City of Surrey
PLANNING & DEVELOPMENT REPORT

Application No.: 7919-0048-00

Planning Report Date: June 15, 2020

to permit the development of a mixed-use high-rise building.

Level 1 King George Plan

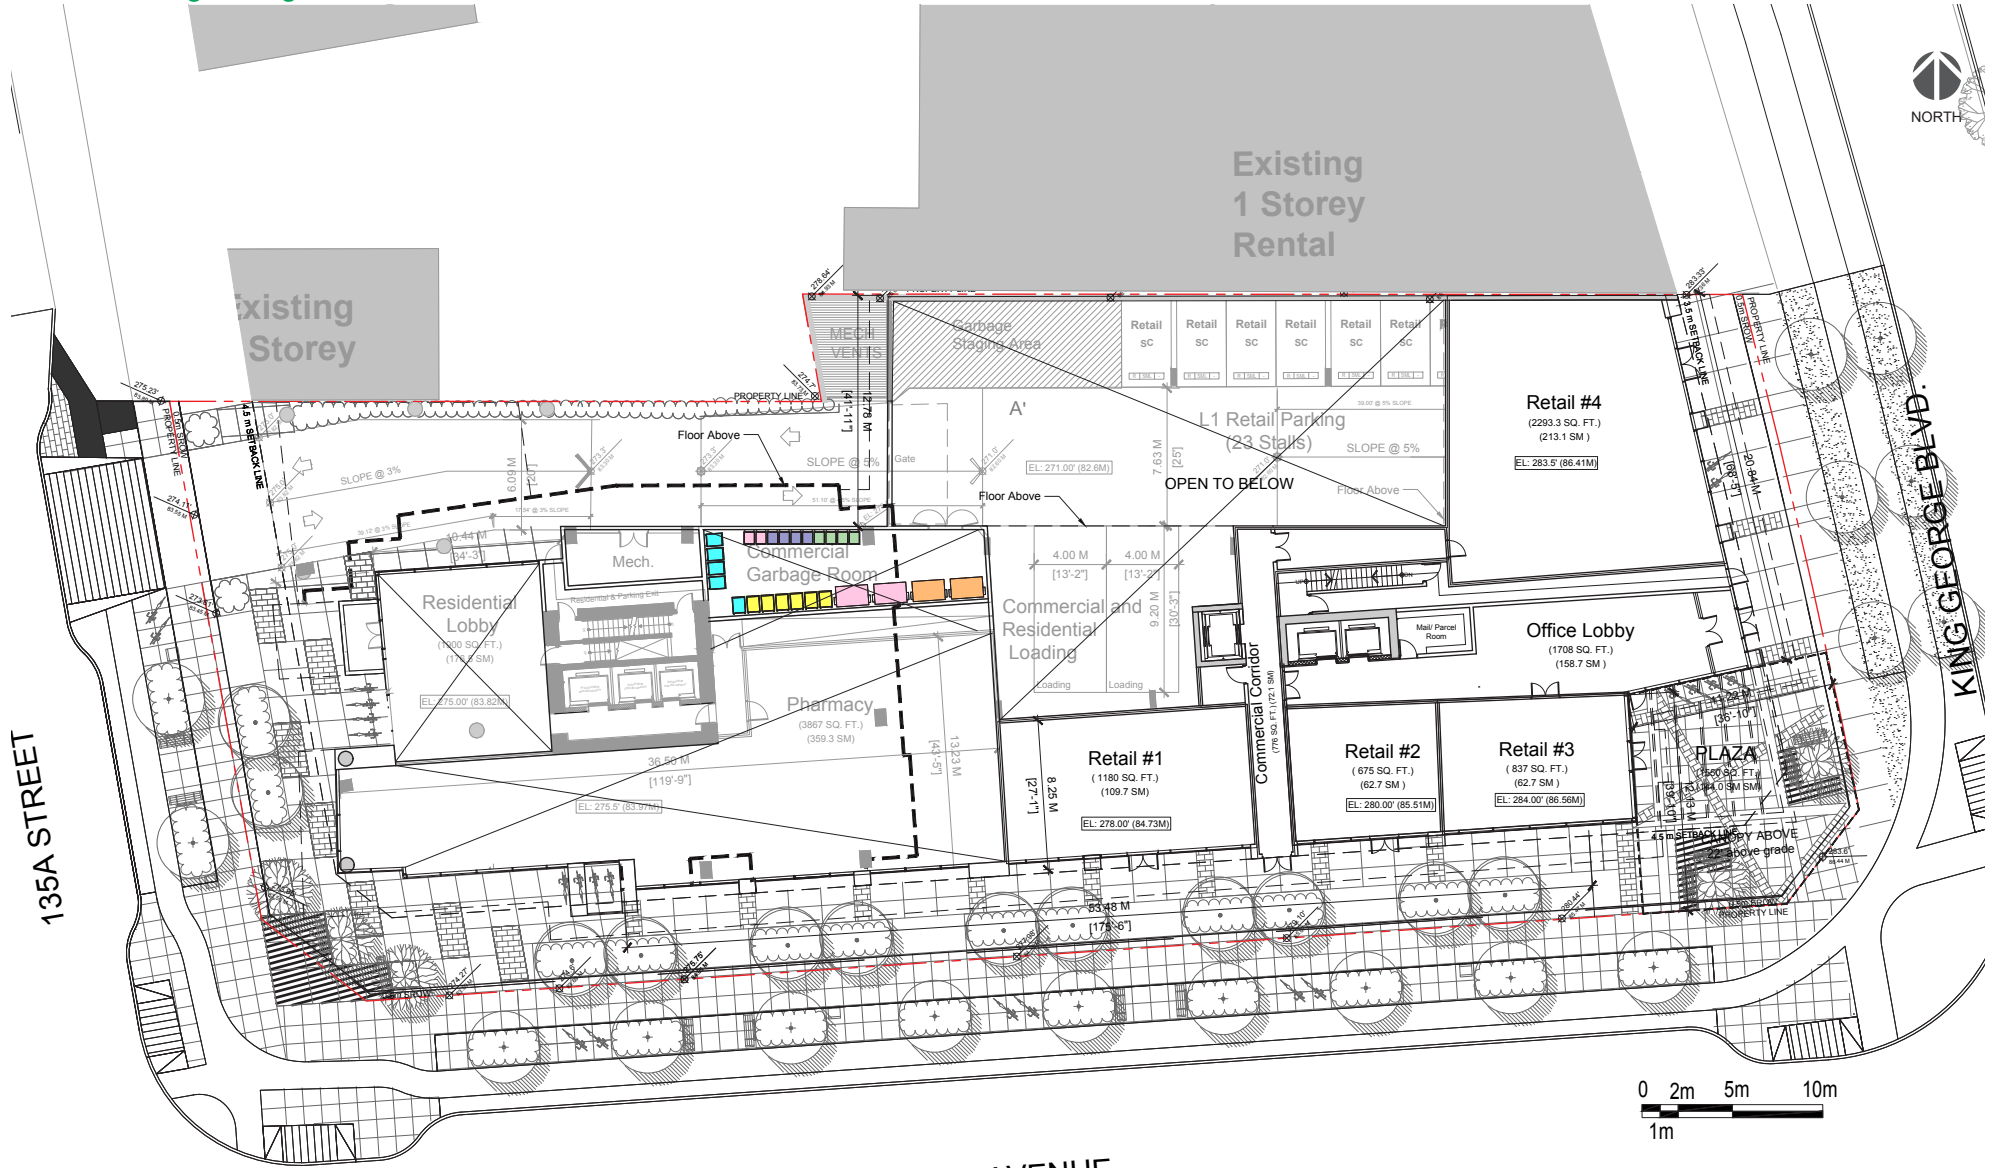
- Consider relocating office entry to King George Boulevard.
Response: Office entry is relocated to the King George Blvd. and 107A Ave. Please refer to page 42, Level 1 Plan.

South Elevation

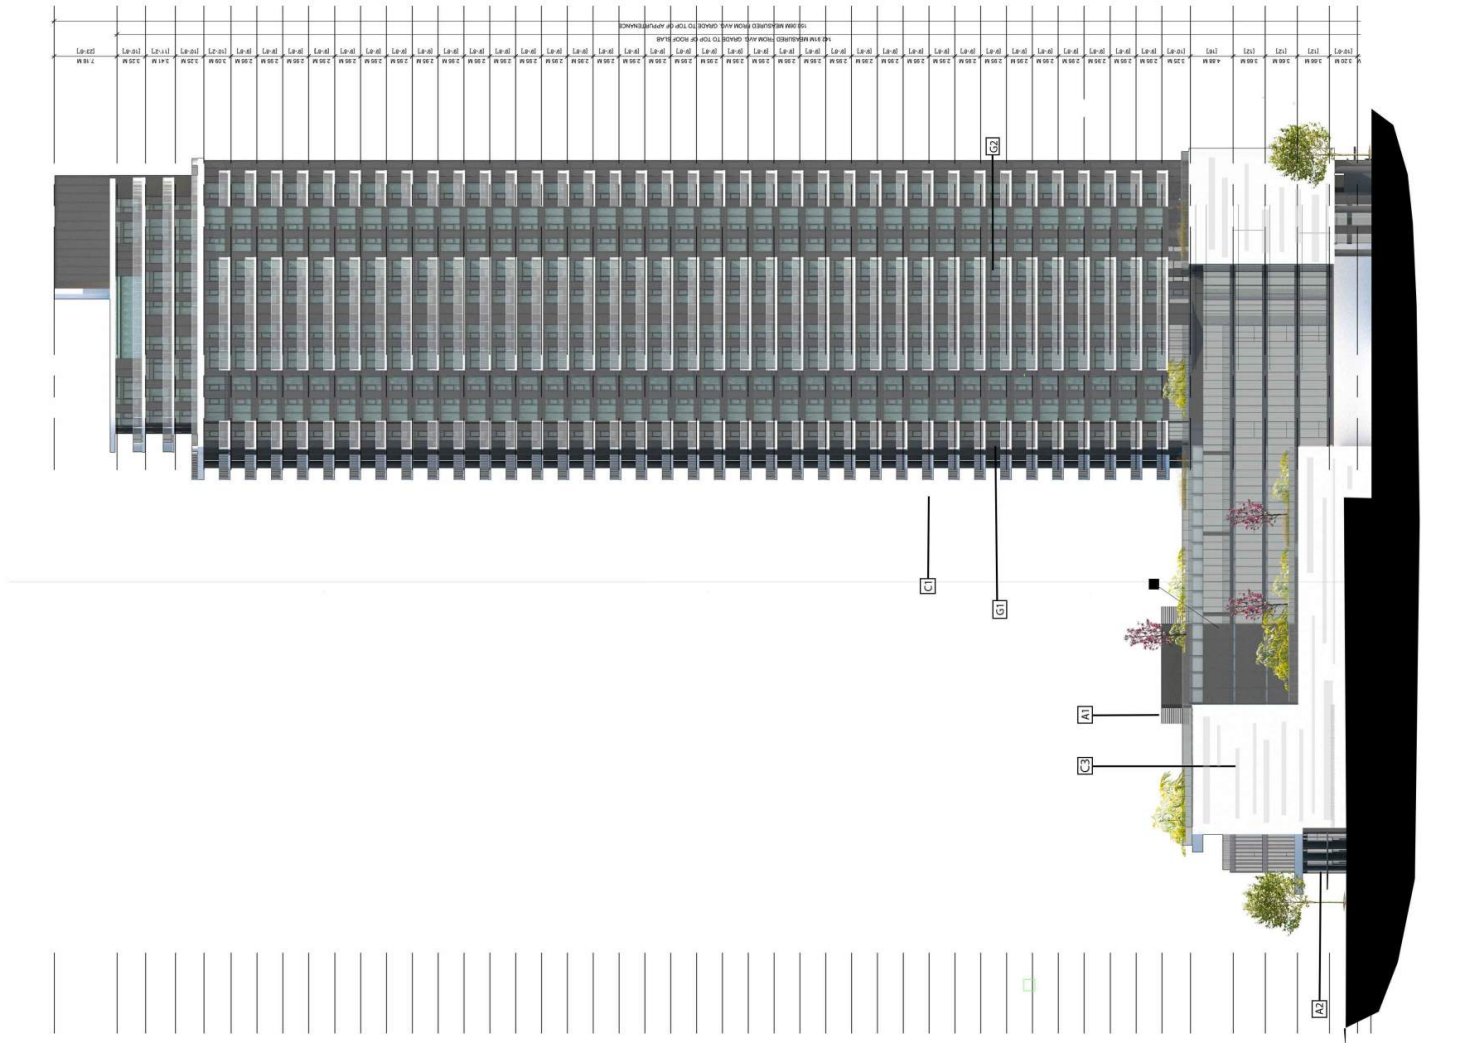
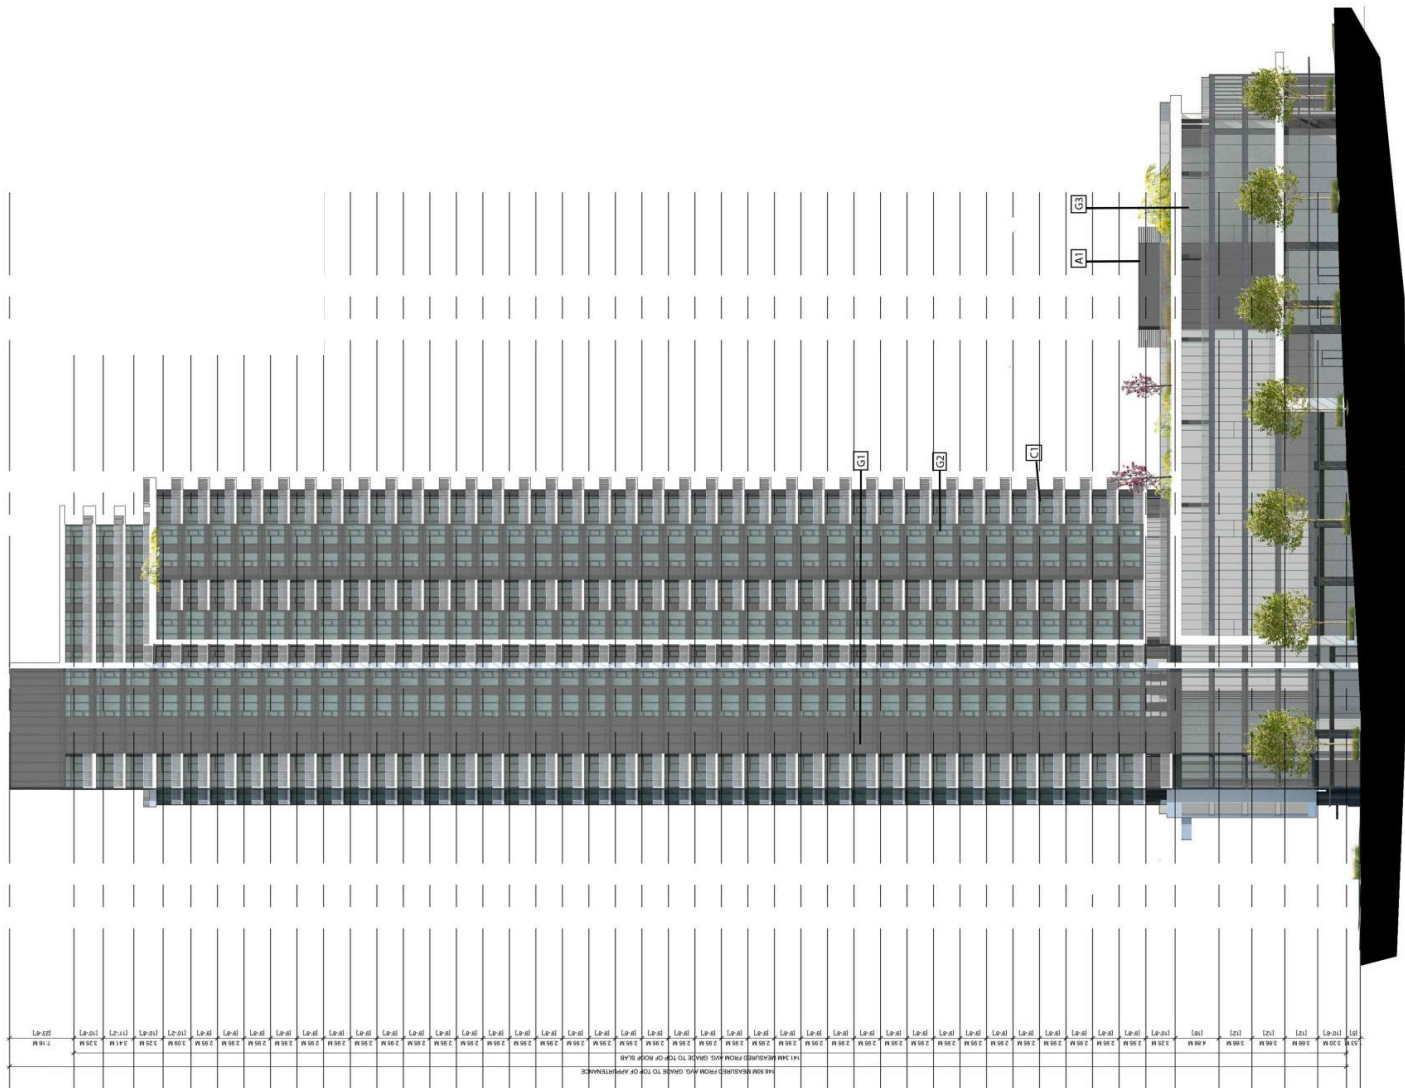
- Recommend more articulation to the south façade of the tower.
Response: Issue is addressed by adding two vertical bars and extending the central balcony 3' outwards. Please refer to page 10 of the resubmission package and color elevations.
